工程指示 / 要求簡箋(E.I.)

工程指示編號：EI / 5635 / 23

工程編號： J - 858

工程名稱：將軍澳日出康城 11

**TITLE:**  
TYPICAL FLOOR PARTIAL ELEVATION & SECTION PLAN FOR CURTAIN WALL (TOWER 1)

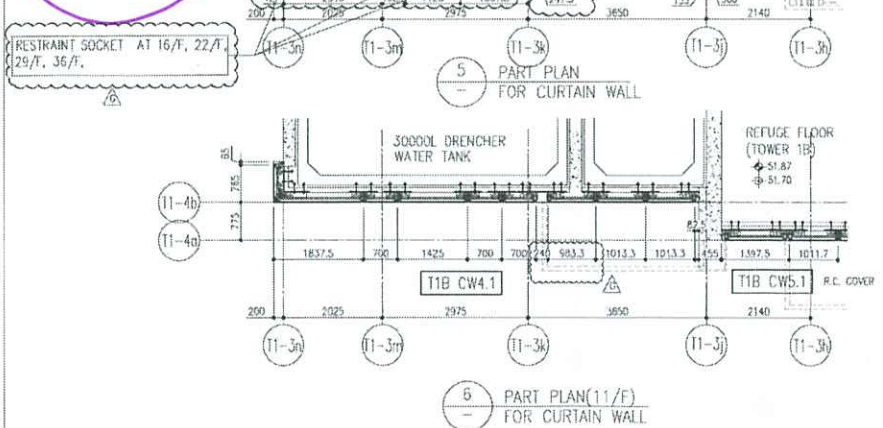
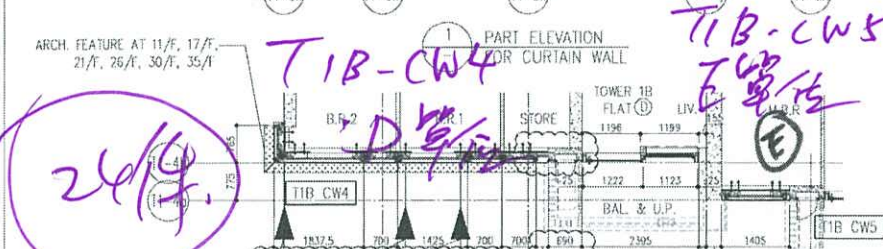
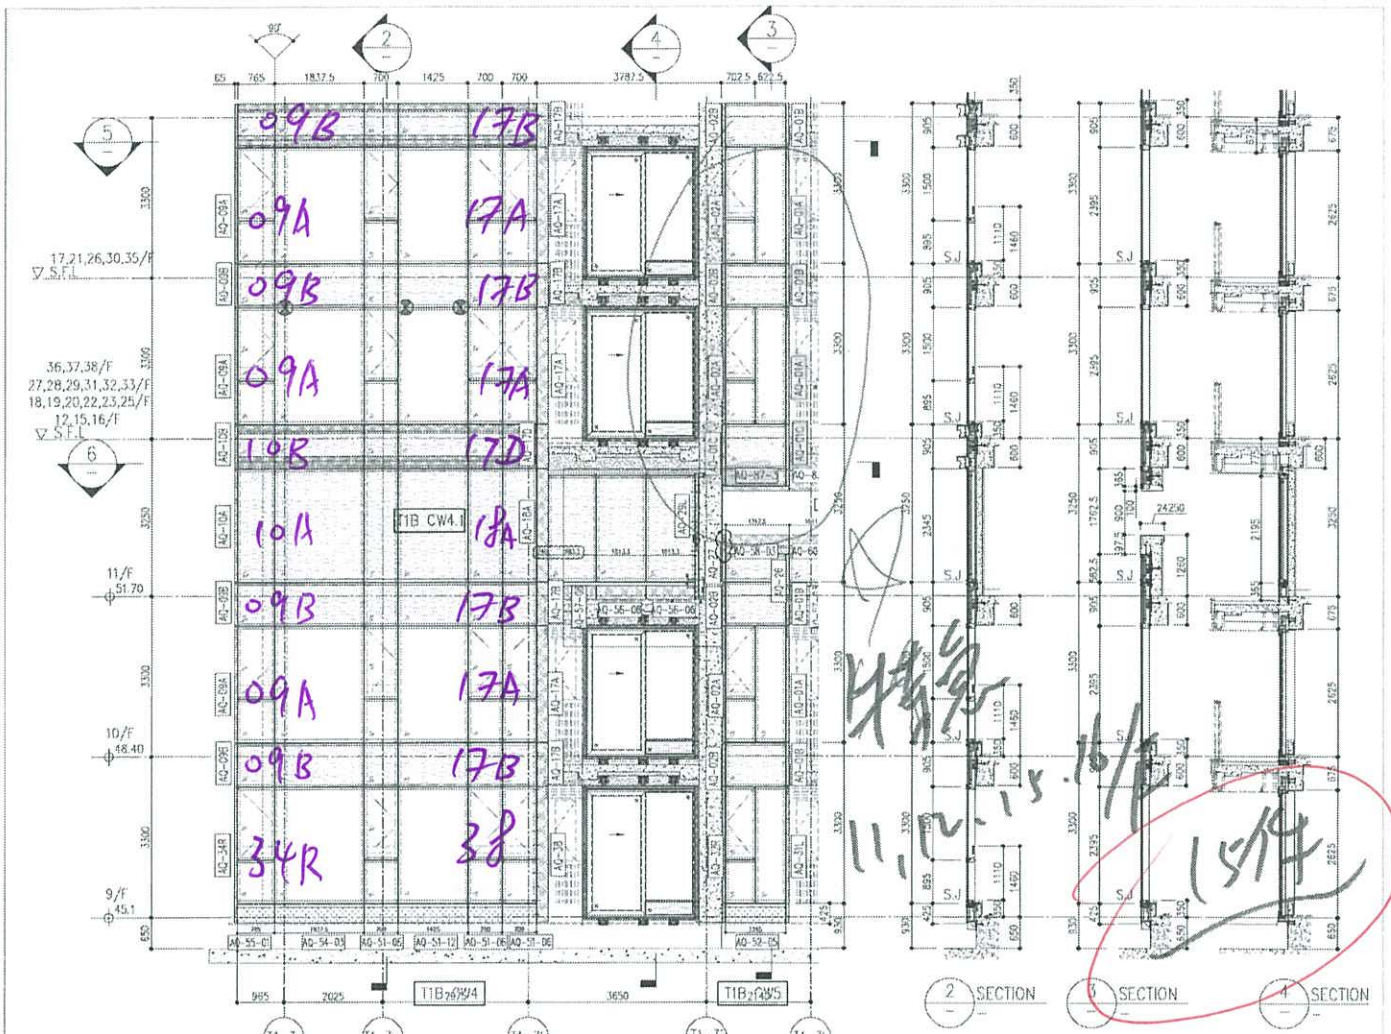
**B 版:** 附上急要的編號。 上次特急 15 件 加 今次特急 24 件 供 T1 B 座-E 單位和 D 單位

3. 請最優先生產 T1 的 12,15,16/ F 供樣板層起貨

T1B - E

11, 12, 15, 16 / F
